**To:** Development Permit Panel

**File:** DP 13-645286

**Re:** Application by Andrew Cheung Architects Inc. on behalf of 684267 B.C. Ltd for a  
Development Permit at 8151 Anderson Road

PROJECT	8151 ANDERSON ROAD RICHMOND
DATE	LEVEL 4 PLAN
PROJECT NUMBER	21212
DRAWN BY	SI
CHECKED BY	BC
SCALE	1:100
DRAWING NUMBER	DP 2.4

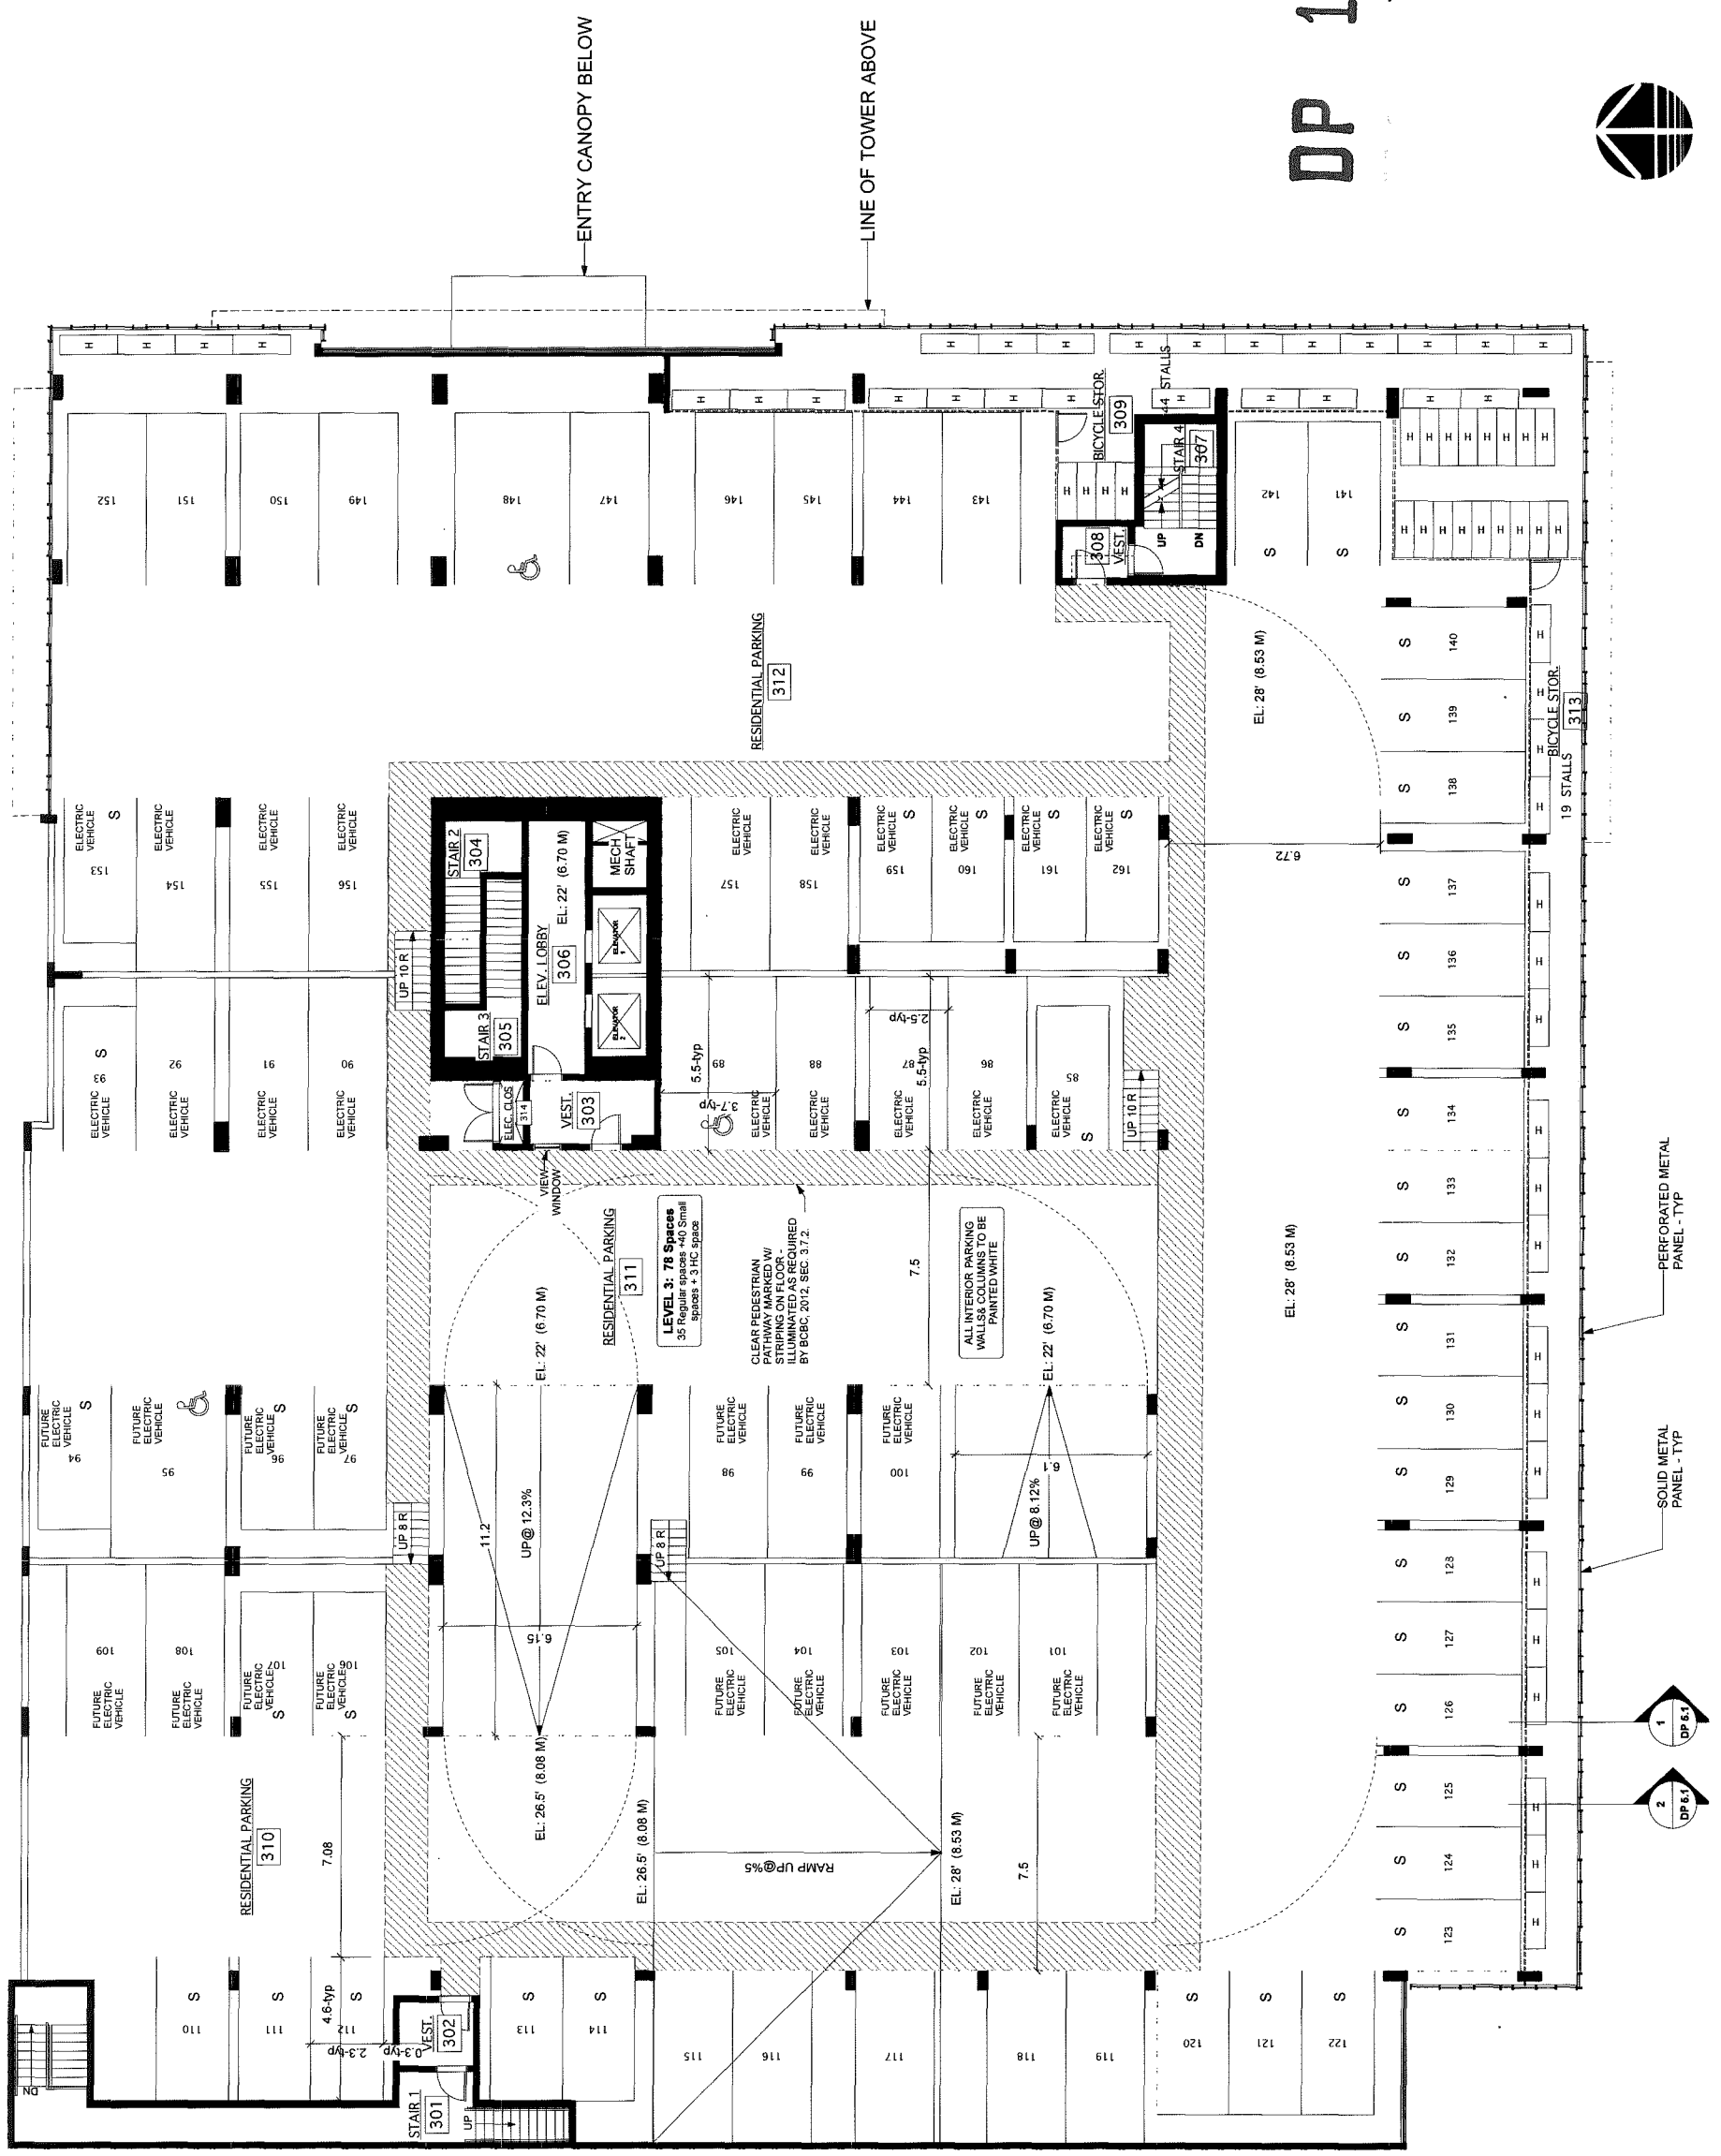
- incorporate pocket doors in lieu of hinged doors in bedrooms and dens; will create extra floor space and provide more access to residents;  
*Acknowledged. Level 4 plan reflects this change.*

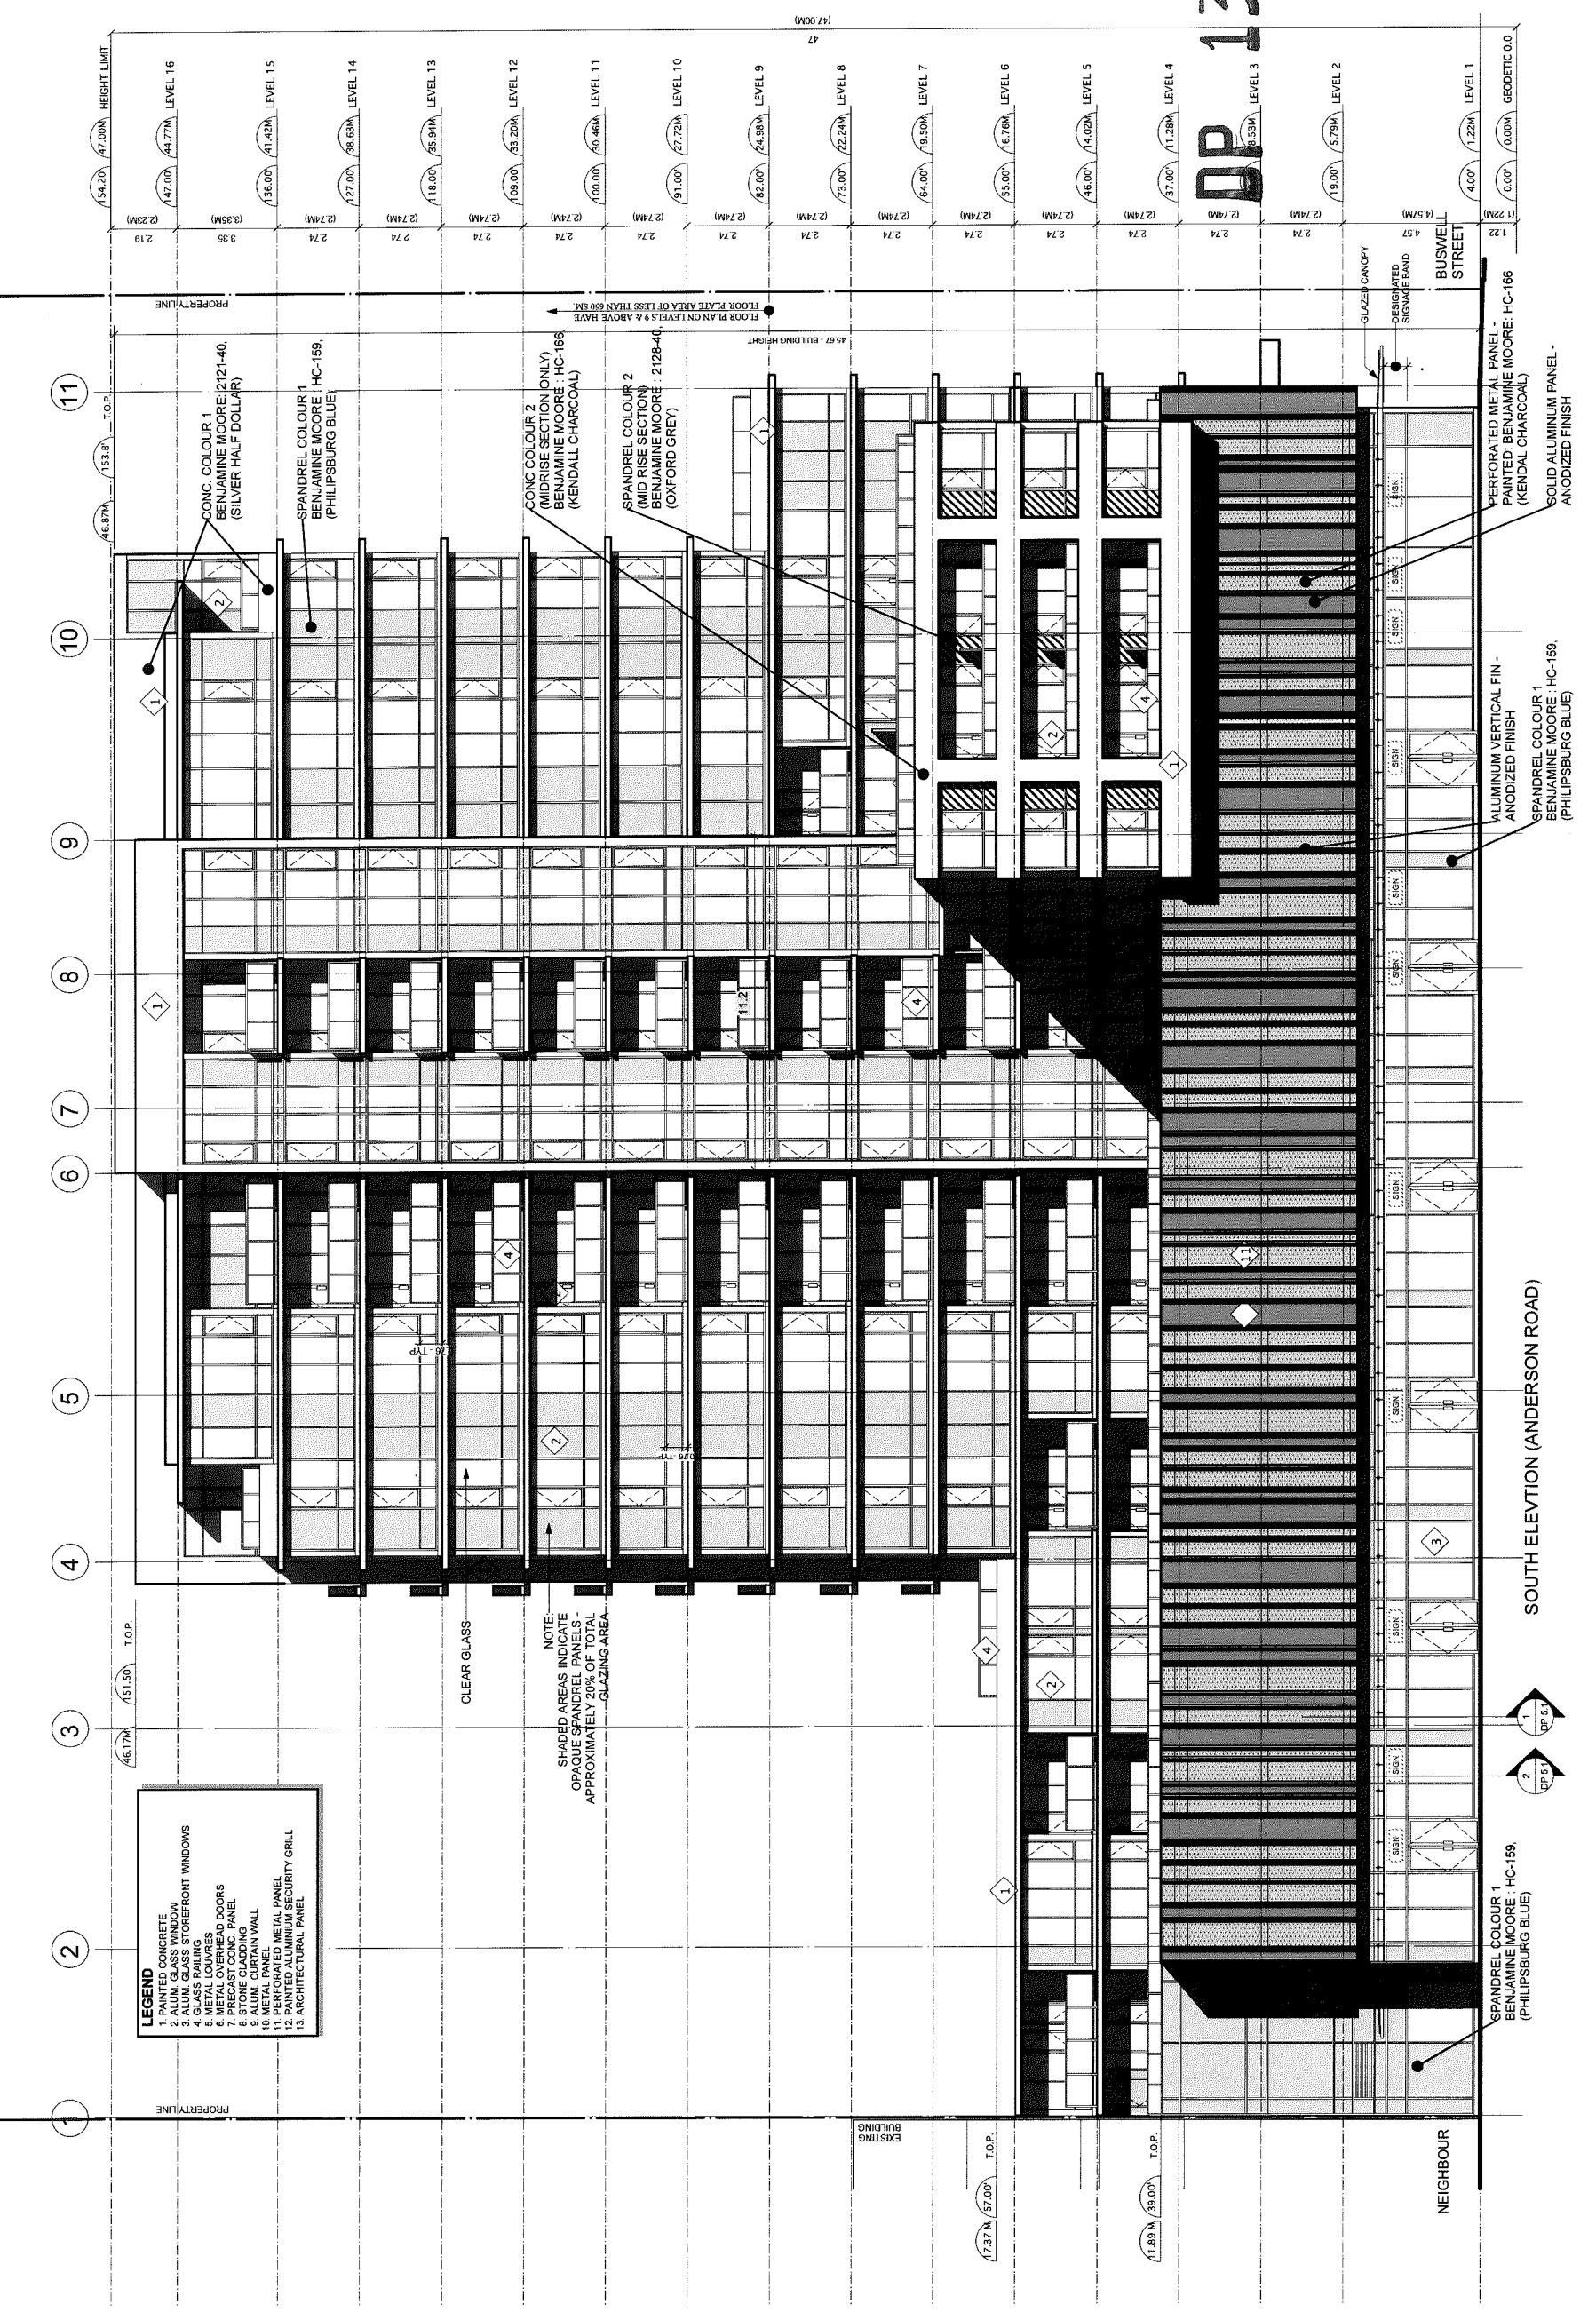
- proposed parkade screening element along levels two and three fronting Anderson Road appears monolithic; concern on (i) how it will be executed, (ii) how it will interface with the public realm and (iii) how it will evolve into a public art piece;  
*The monolithic appearance of the parkade screen along those levels is largely an artefact of the renderings. Regardless, we have revised the proportion between the solid precast concrete panels and the translucent metal screens which make the gap between them to be at least half open. The public art integration with this façade will depend to some degree on the artist selected and the artwork that is ultimately accepted by the selection committee. However, we are confident and convinced that this dynamic pattern of precast vs. metal screen panels is a bold and interesting design for screening above grade parking on its own, without the application of any art work.*
